A G E N D A
CITY OF SEASIDE
PLANNING COMMISSION

B. ARCHITECTURAL REVIEW APPLICATION AR-2024-002. 340 AMADOR LLC, PROPERTY OWNER, AND VILLAZZO GROUP, LLC, PROJECT APPLICANT, REQUEST APPROVAL OF ARCHITECTURAL REVIEW AR-2024-002 FOR CONSTRUCTION OF A NEW THREE-STORY TRIPLEX CONSISTING OF TWO THREE-BEDROOM DWELLING UNITS AND ONE ONE-BEDROOM DWELLING UNIT LOCATED AT 340 AMADOR AVENUE

SUBJECT: ARCHITECTURAL REVIEW APPLICATION AR-2024-002. 340 AMADOR LLC, PROPERTY OWNER, AND VILLAZZO GROUP, LLC, PROJECT APPLICANT, REQUEST APPROVAL OF ARCHITECTURAL REVIEW AR-2024-002 FOR CONSTRUCTION OF A NEW THREE-STORY TRIPLEX CONSISTING OF TWO THREE-BEDROOM DWELLING UNITS AND ONE ONE-BEDROOM DWELLING UNIT LOCATED AT 340 AMADOR AVENUE (APN 011-315-003) IN THE RM/POS ZONING DISTRICT OF THE WEST BROADWAY URBAN VILLAGE SPECIFIC PLAN.

Site Plan/ Design Review Application for 340 Amador Avenue

Sheet A.1.1

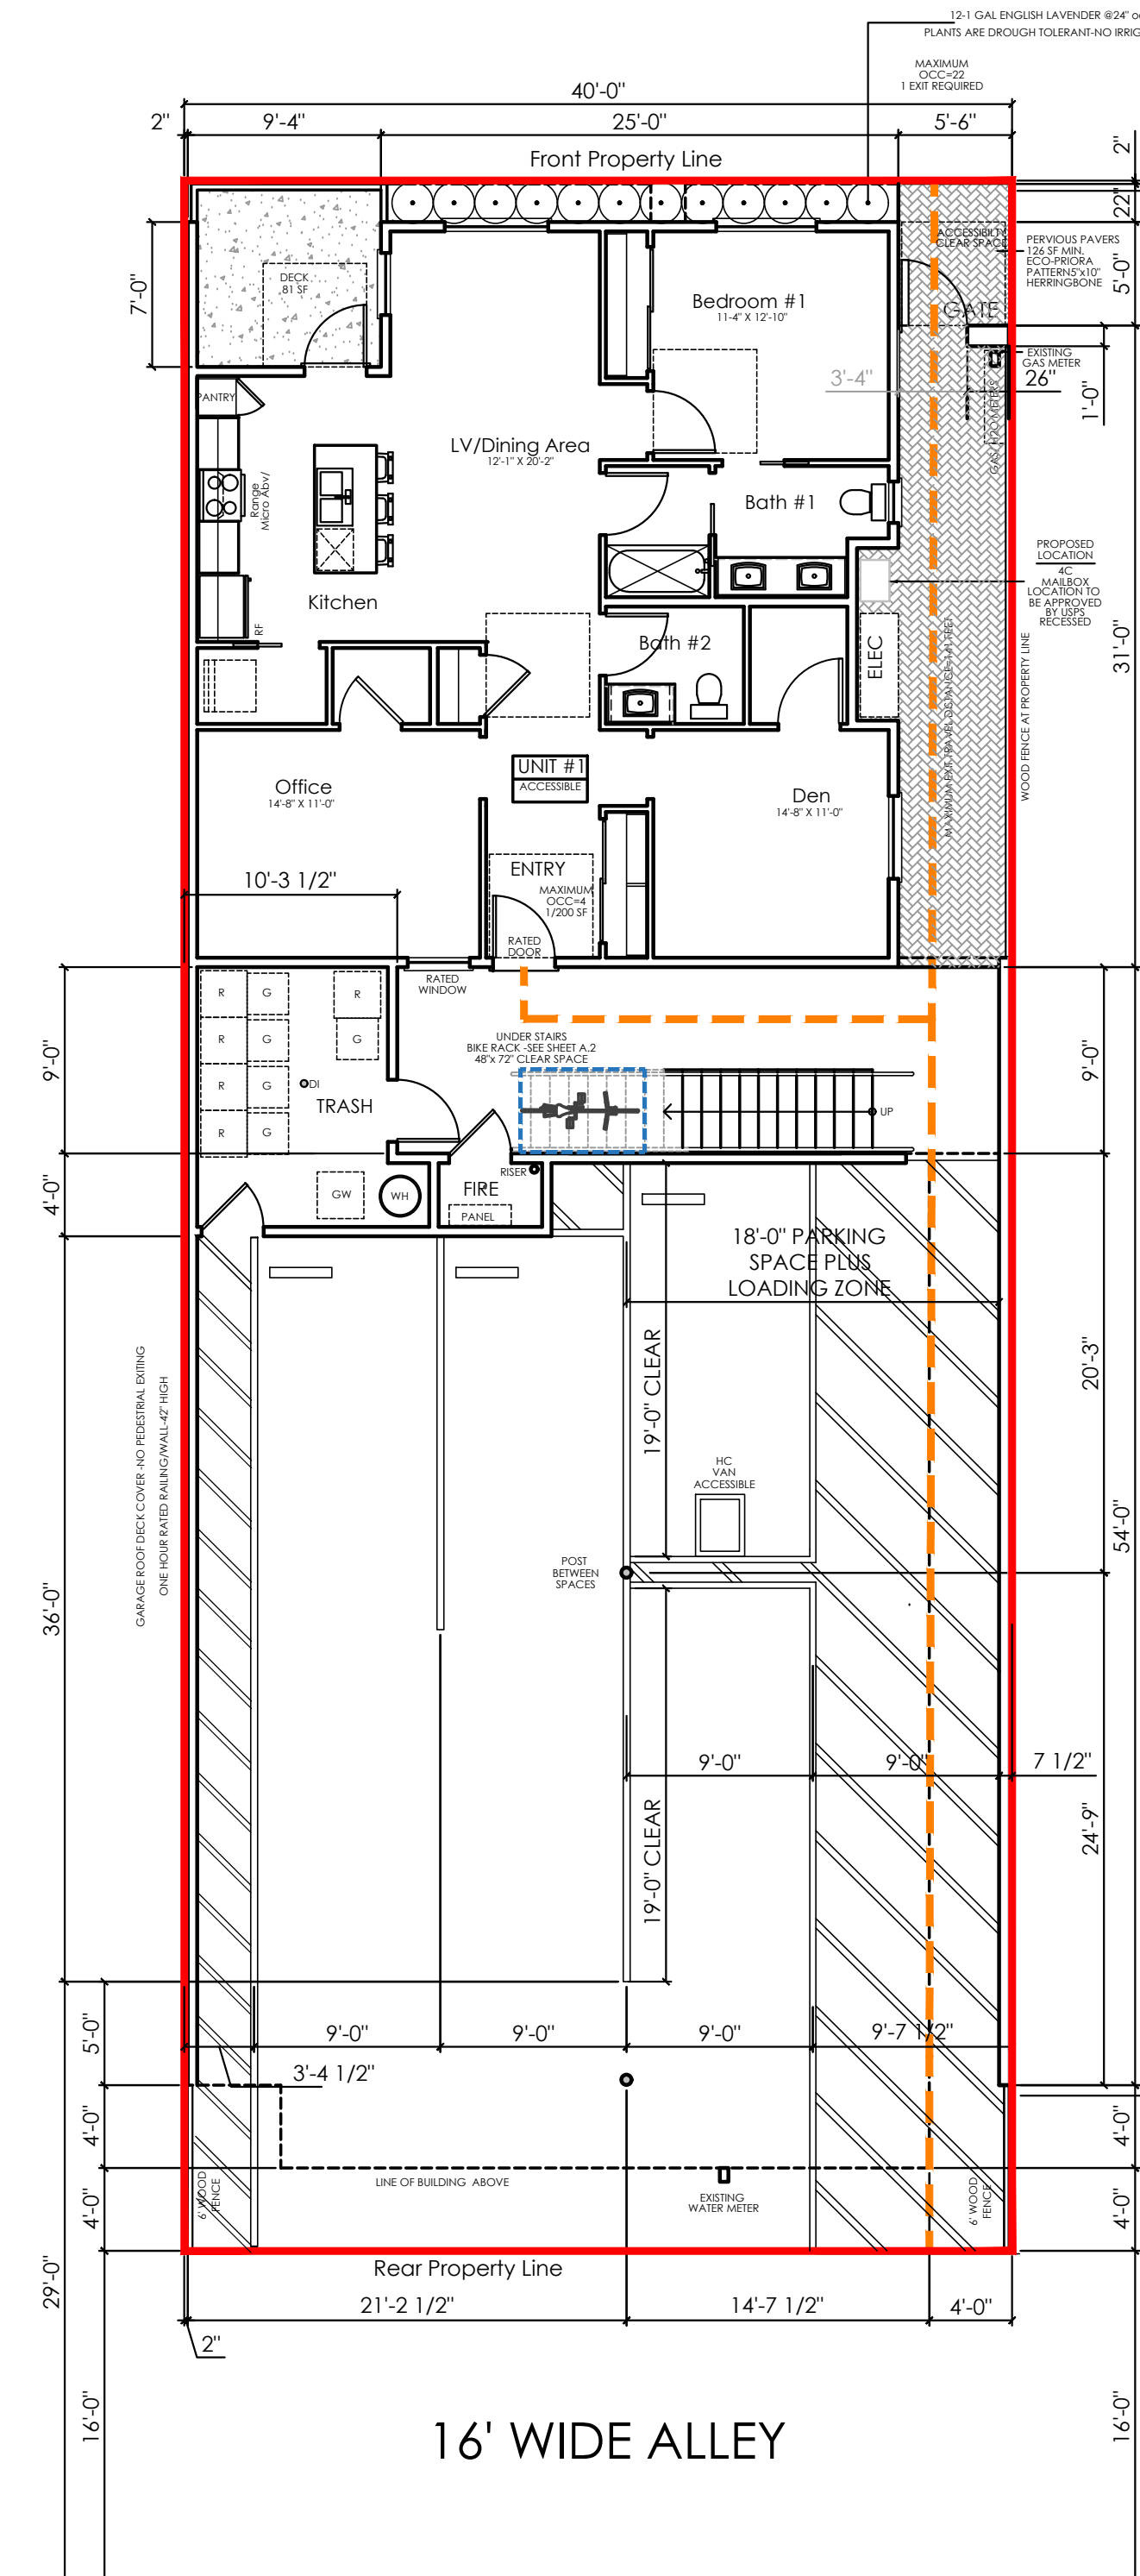
Following public comment, Commissioners discussed the project. Commissioner Ward stated that the site plan was too small in scale, difficult to read, and contributed to confusion, and reiterated concerns about parking. Commissioner Dodson asked how the parking stall dimensions were tested. Commissioner Evans expressed concern that the use of a Ford Escape as a test vehicle was not representative, noted the narrow alleyway and existing parking challenges on Amador Avenue, and stated that with nine bedrooms, the project would likely generate more than five vehicles, making the current design unworkable. He recommended that the project be scaled back.

Commissioner Ward reiterated that the plans available online were difficult to read and recommended resubmission with a more detailed and legible site plan, as well as revisions to provide additional space.

The project was presented at the Planning Commission meeting on March 25, 2026. Planning Commission objected to providing exceptions to the parking standards for this project. The project was continued to the April 22, 2026 regular meeting to provide the applicant with the opportunity to adjust the plans in response to Planning Commission's concerns.

The first floor dwelling unit was reduced from three bedrooms to one bedroom. This change reduces the parking requirement from five parking spaces to four parking spaces in accordance with the WBUV 7.B.8.2 requirement of 1 parking space for units with one bedroom and 1.5 parking spaces for units with two or more bedrooms.

The trash room was moved and reconfigured. Condition of approval #6 was added to require Greenwaste approval of the new configuration be submitted at the same time as the Building Permit application. A provision was added to allow the Zoning Administrator to approve changes to the layout that Greenwaste finds necessary. Condition of approval #7 was added to ensure that moisture from the trash room will drain to the sanitary sewer system.

The second floor walkway was clarified to show that it will extend to the east side property line and connect to the walkway adjacent to the ADUs.
